Access Compliance Report

Public Rights-of-Way

Intersection ID: 30218	Main Street: FINBOROUGH_CT	Cross Street: MONTBROOK_DR	Location: NW
ADA ID: C28BCC36C062	Ramp Type: PerpDiag	Initial Pass/Fail: Fail	Overall Compliance: No
		Severity Score: 30

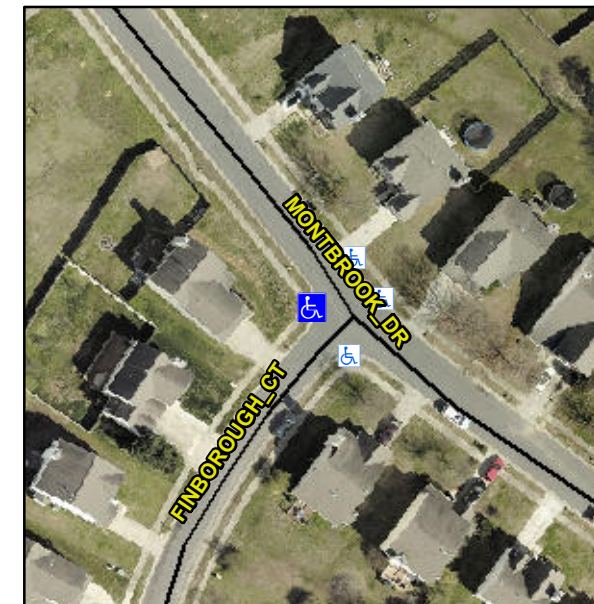
Not Found, R304.5.1, R304.5.3

Compliance	Description	Data	Compliance	Description	Data
N/A	Ramp Length (in)	49.0	Yes	Ramp Slope (%)	7.6
No	Ramp Width (in)	35.5	No	Ramp XSlope (%)	6.3
N/A	Flare Type LT	N/A	N/A	Flare Type RT	N/A
N/A	Flare Slope LT (%)	N/A	N/A	Flare Slope RT (%)	N/A
N/A	Flare Traversable LT?	N/A	N/A	Flare Traversable RT?	N/A
N/A	Landing Length (in)	N/A	N/A	DWS Provided?	N/A
N/A	Landing Width (in)	N/A	N/A	DWS Contrast?	N/A
N/A	Landing Slope (%)	N/A	N/A	DWS Length (in)	N/A
N/A	Landing X Slope (%)	N/A	N/A	DWS Full Width?	N/A
N/A	Landing Curb? (Y/N)	N/A	N/A	DWS Offset (in)	N/A
N/A	Shared Landing?	N/A			
N/A	Gutter Ponding?	N/A	N/A	Gutter Slope (%)	N/A
N/A	Gutter Lip Ht (in)	0.5	N/A	Gutter X Slope (%)	N/A
N/A	Painted X Walk1?	No	N/A	Painted X Walk2?	No
	X Walk 1 Direction	To S		X Walk 2 Direction	To E
N/A	X Walk 1 Width (in)	N/A	N/A	X Walk 2 Width (in)	N/A
	X Walk 1 Slope (%)	1.7		X Walk 2 Slope (%)	5.3
	X Walk 1 X Slope (%)	5.8		X Walk 2 X Slope (%)	1.3

Remove & Replace Curb Ramp With Two New Directional Ramps or Equivalent.
